Product Change Notice (PCN)

PCN Number: PCN-0381408R-01

Product(s) Affected: CMS-160916-30-3

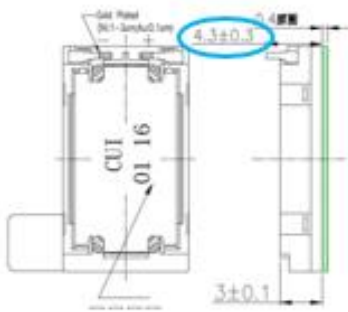
Description of Change: Power rating change to 0.8W rated; sound pressure level change to 88dB @ 0.8/10cm; resonant frequency change to 600Hz; THD change to 15% max; multiple housing/appearance modifications as shown below:
